Current COM spec is broken between channel and Rx (comment #32)

Yasuo Hidaka
Fujitsu Laboratories of America, Inc.

IEEE P802.3cd Task Force,
New Orleans, LA, May 22-23, 2017

hidaka_3cd_01a_0317, slide 12, right half

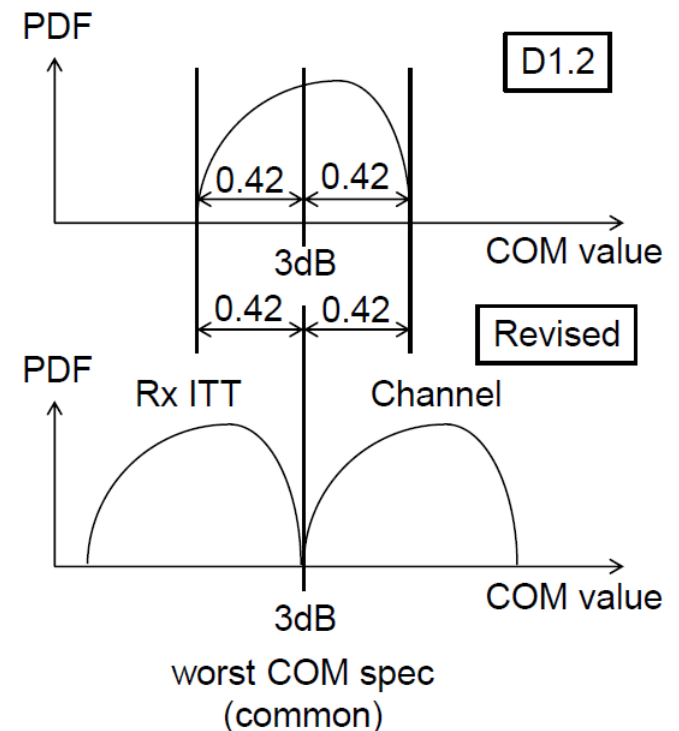
- Check COM for all max/min combinations of R_d and Z_c in Tx and Rx (i.e. search for the worst COM value)

- Brute-force search can be accelerated by two-phase optimization of LE
- Major change of COM tool is required

- Define the worst COM value as follows:

- *Min* COM value for Channel Test
- *Max* COM value for Rx ITT

- For Z_c (nominal) = 93Ω

- Worst common = 3.0dB

hidaka_3cd_01a_0317, slide 13, right half

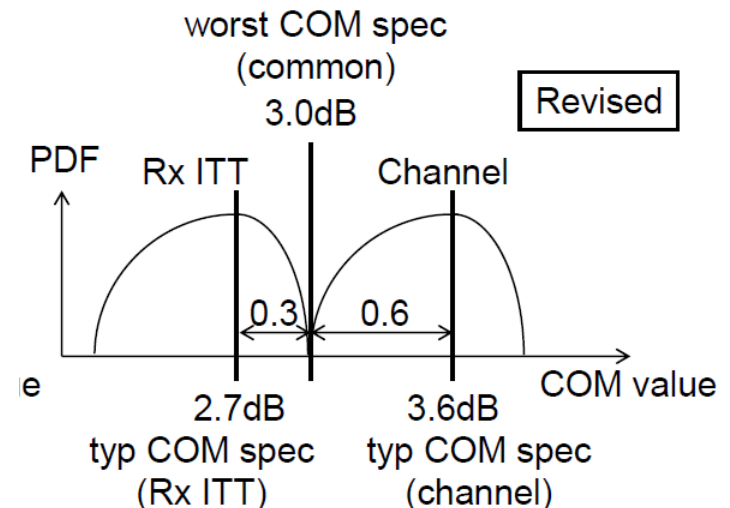
- Check the typical COM value for nominal values of R_d and Z_c
 - No COM tool change is required

- Offset COM spec value as follows:

- For Channel Test, X dB higher than the worst COM spec (option 1)
- For Rx ITT, Y dB lower than the worst COM spec (option 1)
- X and Y are chosen base on the amount of variation

- For Z_c (nominal) = 93Ω

- Typ Channel = 3.6dB
- Typ Rx ITT = 2.7dB

Fairly Revised Worst Common Spec for Option 1

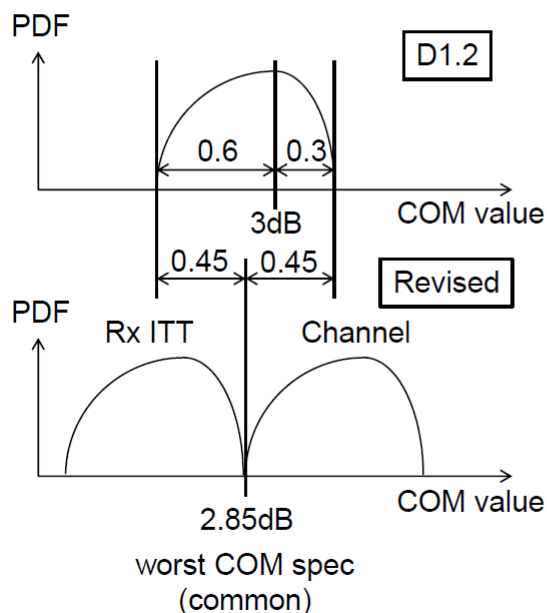
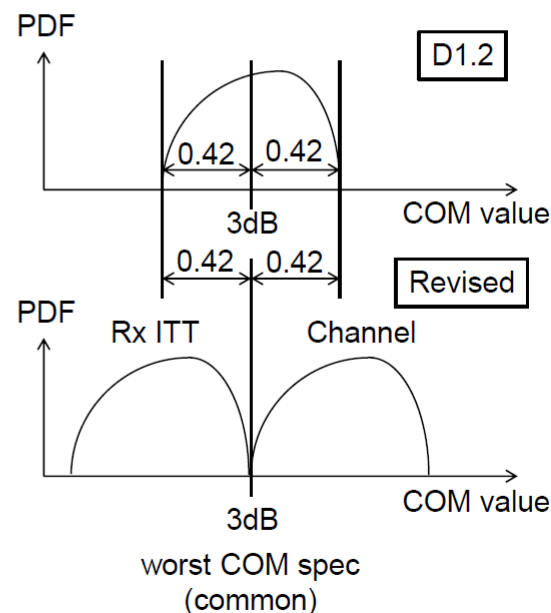
Options for the nominal value of Package Zc

■ For Zc (nominal) = 100Ω

■ Worst common = 2.85dB

■ For Zc (nominal) = 93Ω

■ Worst common = 3.0dB

■ For 93Ω, recommend to keep COM spec value of 3dB

■ For 100Ω, recommend to change COM spec value to 2.85dB

■ For 95Ω or 90Ω, no data at this moment
